Submitter No. 23

Alan Jefferies

Submission  
in relation to  
Proposed Plan Change 42  
to the Upper Hutt City Council District Plan

**UPPER HUTT CITY COUNCIL  
HAZARDS MAP**

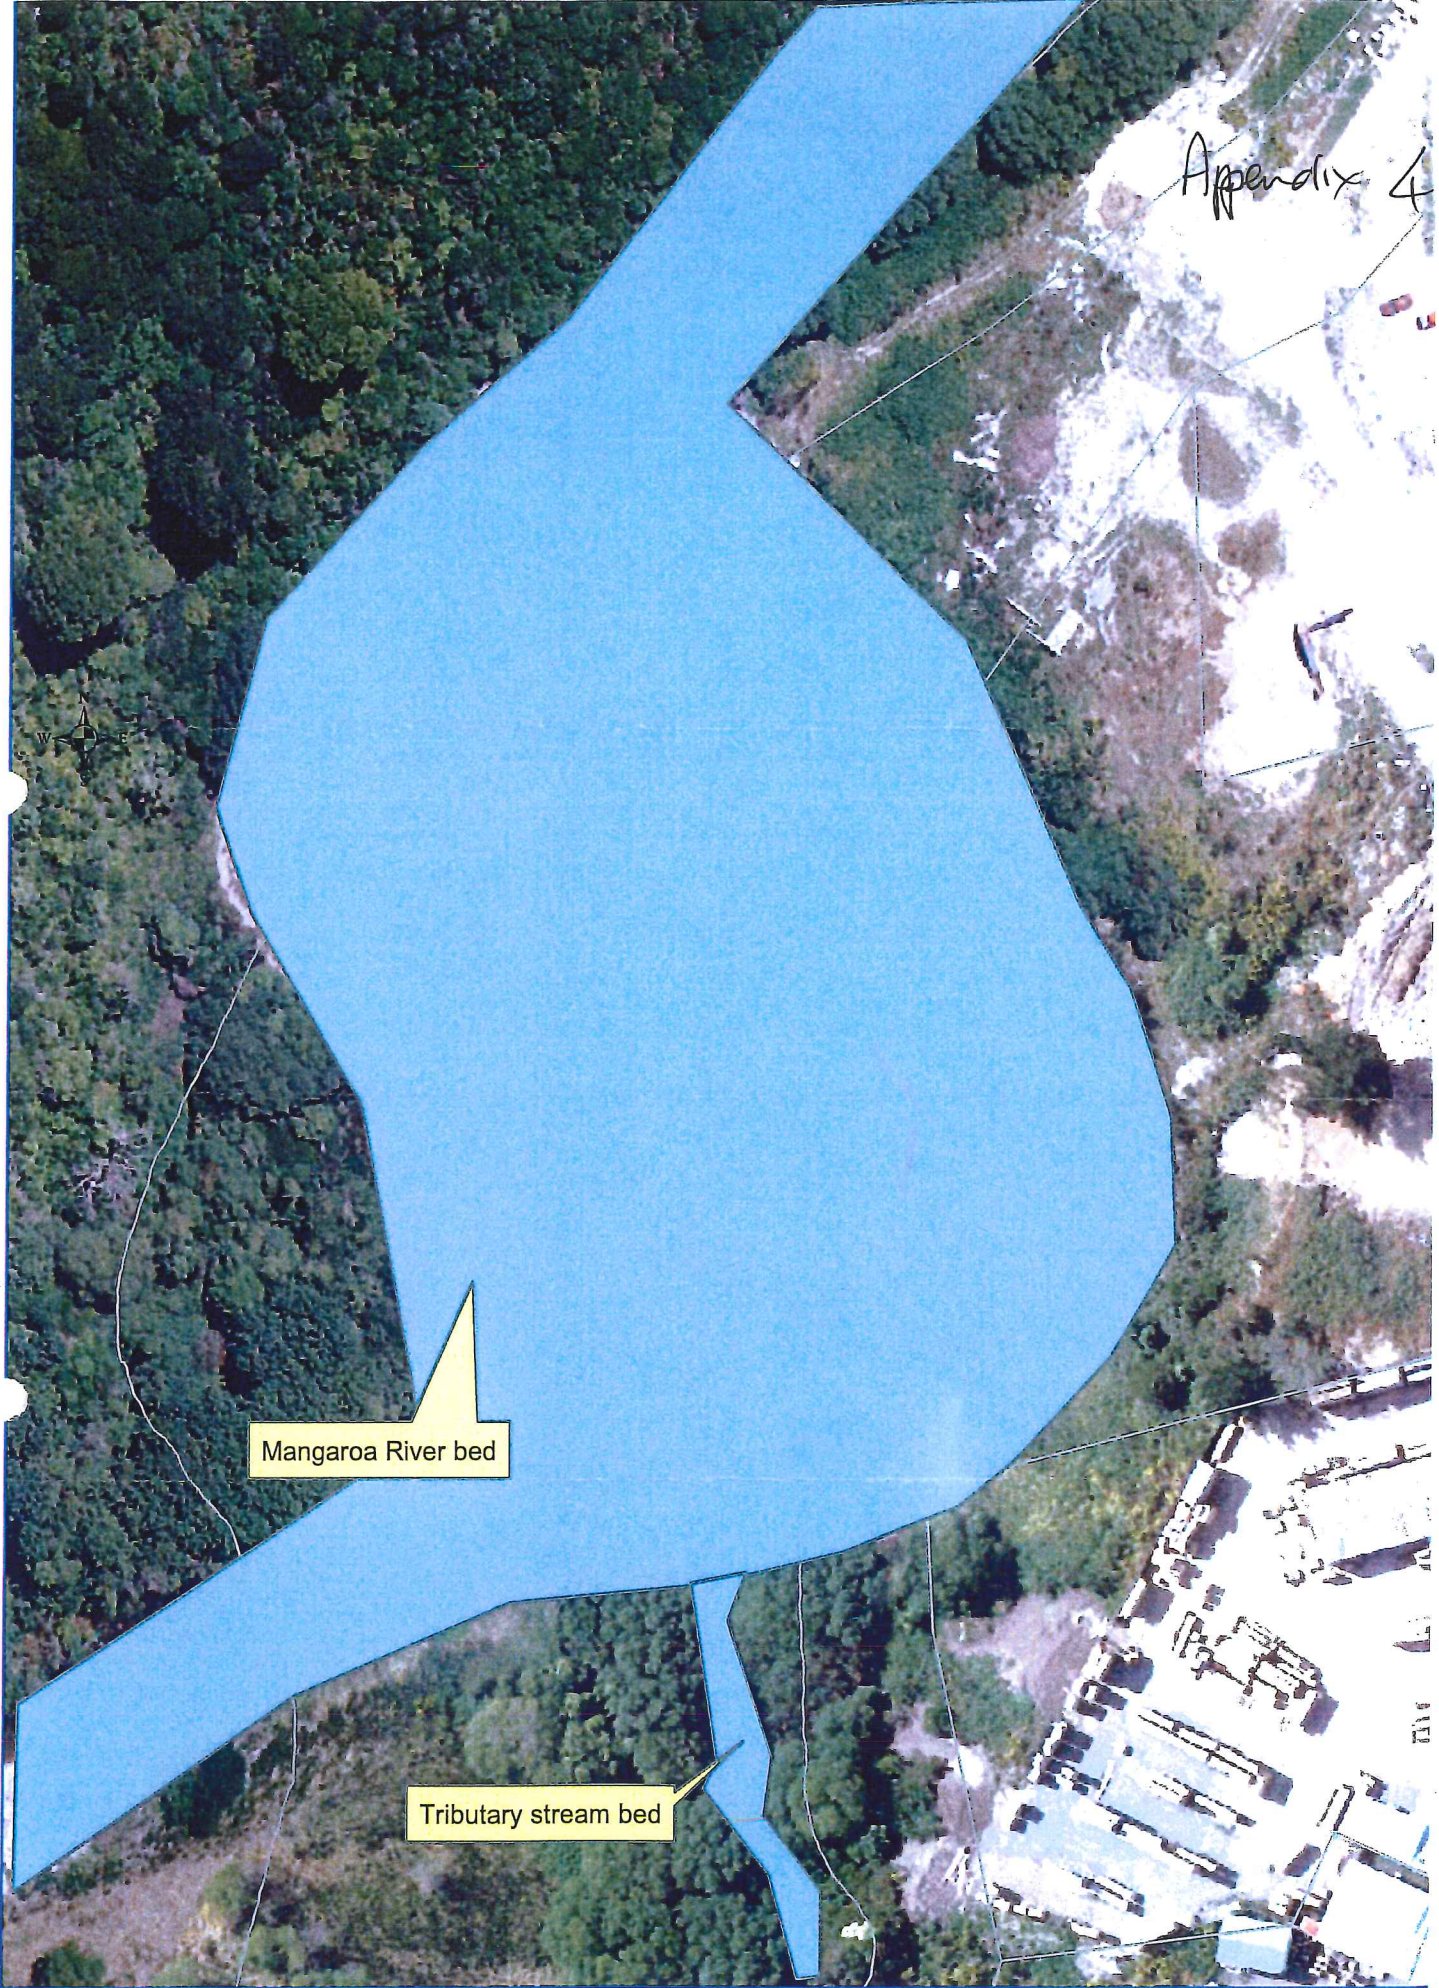
4. The so called erosion hazard line is farcical and in order to understand that it is please again turn to Appendix 1 – Map.

In relation to my land [which has a steep eroding bank on it] the so called erosion hazard line is located HALF WAY up that bank.

If the line is supposed to represent a building set back line, then why I ask, would it be sensible to allow building to occur half way down a pre-existing steep eroding bank. The line is ABSURD.
